Addendum #03 for RFB #911800-02

Project Name: IVH-Mechanical & Electrical Distribution System Replacement

DAS Project #: 9018.00

Addendum #3:

5 BOILER STEEL STAIR AND PLATFORM DEMOLITION AND NEW INSTALLATION
NOT TO SCALE

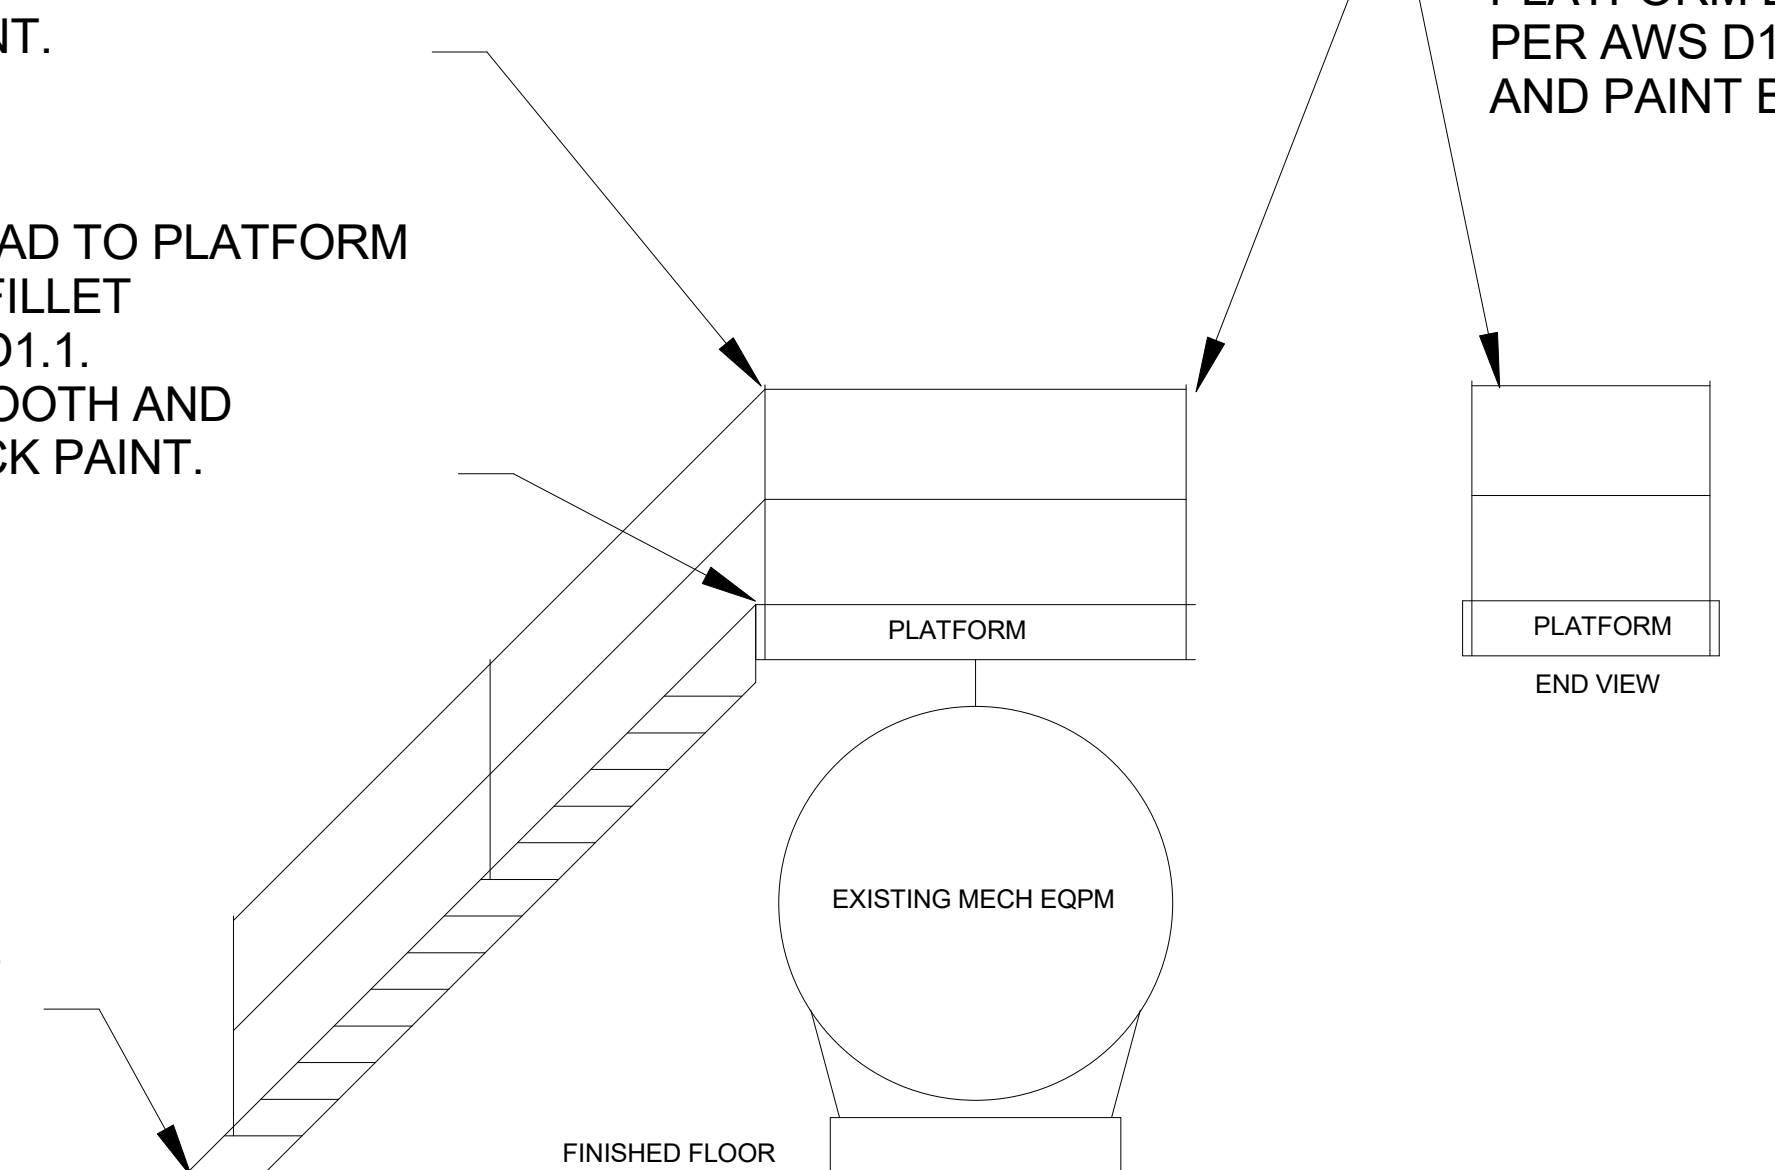
WELD RAILING ON TREAD TO END OF RAILING ON PLATFORM WITH FILLET WELD PER AWS D1.1. GRIND WELD SMOOTH AND PAINT WITH BLACK PAINT.

WELD STAIR TREAD TO PLATFORM BASE WITH TEE FILLET WELD PER AWS D1.1. GRIND WELD SMOOTH AND PAINT WITH BLACK PAINT.

ANCHOR STAIR TREAD BASE TO FLOOR WITH NEW CONCRETE ANCHOR BOLTS.

WELD HORIZONTAL RAILING TO VERTICAL RAILING SUPPORTS AT PLATFORM END WITH TEE FILLET WELDS PER AWS D1.1. GRIND WELDS SMOOTH AND PAINT BLACK.
